STAFF REPORT  
WEST ALLIS PLAN COMMISSION  
WEDNESDAY, OCTOBER 25, 2017  
6:00 PM

- 3A. Special Use Permit for Super Liquor & Grocery, a proposed liquor and grocery store and mixed use, to be located at 5801-5815 W. Beloit Rd. submitted by Paraminder "Goldie" Singh and Iqbal Kaur of GGI Real Estate, LLC (prospective property owner).
- 3B. Site, Landscaping and Architectural for Super Liquor & Grocery, a proposed liquor and grocery store and mixed use, to be located at 5801-5815 W. Beloit Rd. submitted by Paraminder "Goldie" Singh and Iqbal Kaur of GGI Real Estate, LLC, prospective property owner (Tax Key No. 455-0098-000).

**CORNER and EAST ELEVATIONS**

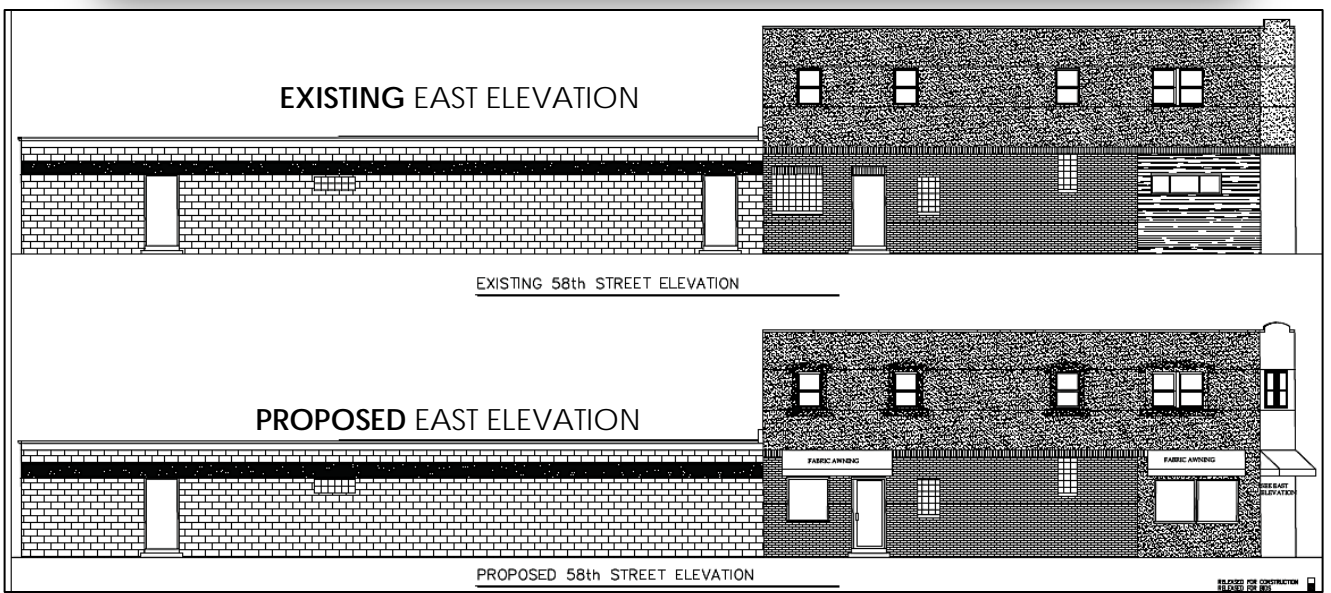
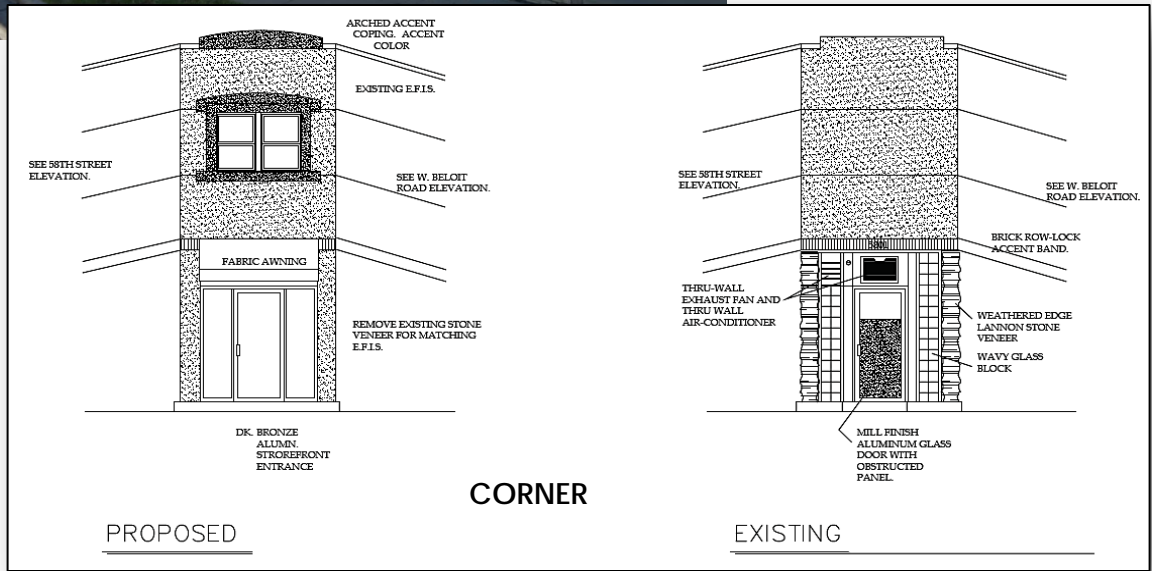
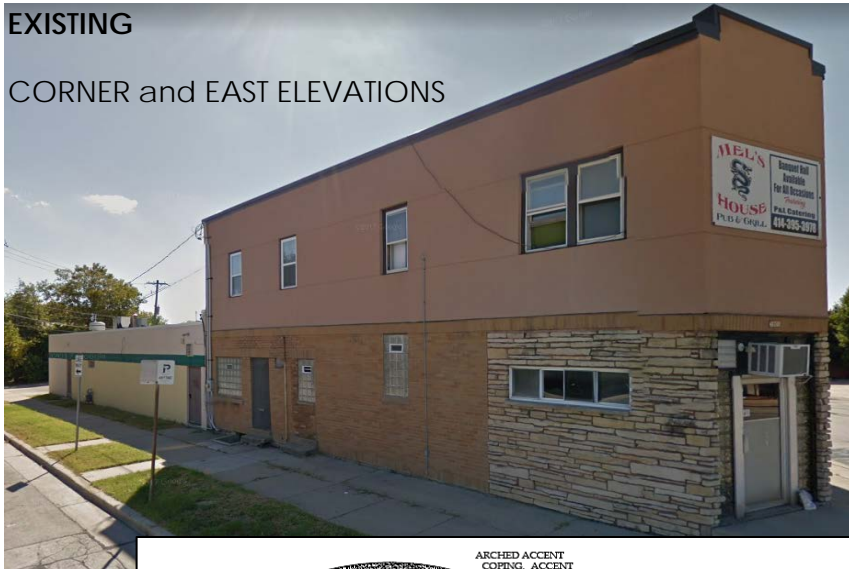
- a. No new EIFS as proposed at storefront. Alternates recommended or keep existing lannon stone (at minimum).
- b. The existing EIFS coating which covers brick on the second floor is proposed to remain. Consider removing some EIFS (a test area) to investigate the previous method of attaching the EIFS covering and quality of brick beneath.
- c. Window sills being added/specified on plan under new window areas. Confirm window transparency on plans.
- d. Confirm style/spec and color of exterior material details on plans including window framing, trim, brick, doors, awnings.
- e. Awning details. Fabric is good as proposed, but the style suggested could be updated for a more contemporary look (perhaps steeper pitch and no sides)
- f. Additional awning being added over east (kitchen) door).
- g. Any new lighting on the exterior of the building needs to be indicated on plan.

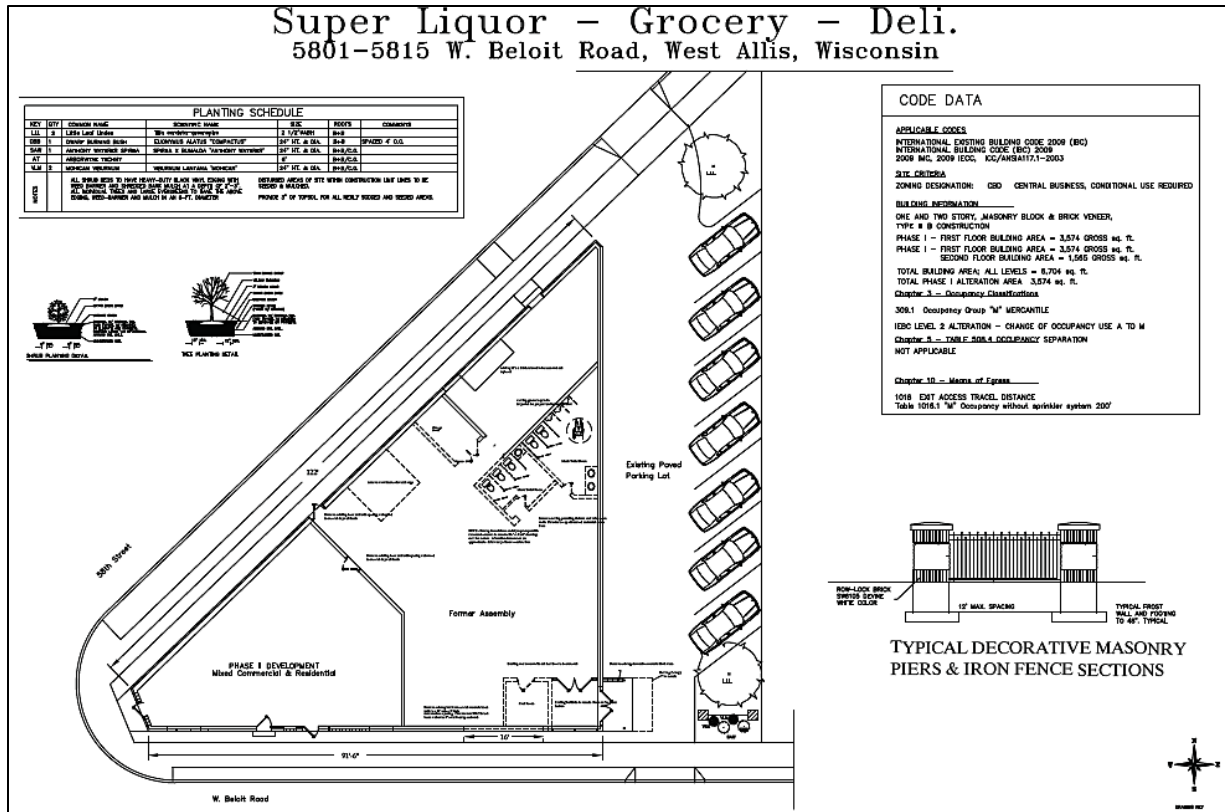
Cars pull up to the edge of pavement facing a residential home to the west. The abutting residential property to the west has an existing fenced rear yard, but the remainder of the property is exposed to the existing parking area of the commercial property. There is about 3-ft between the house to the west and the property line of the subject commercial property.

Staff would prefer there be some additional buffer between the parking lot and residential home, but there isn't much room as is. Given angled parking, staff is recommending some buffer be added by removing some

asphalt along the west side of the parking lot for a landscape area and/or flipping the orientation of the stalls.

The architect is working on a revised plan that flips the orientation of the parking lot to face the building. This would also promote some additional greenspace area along the west edge of the parking lot for inclusion of some landscape screening. Additional details to be provided at the meeting.
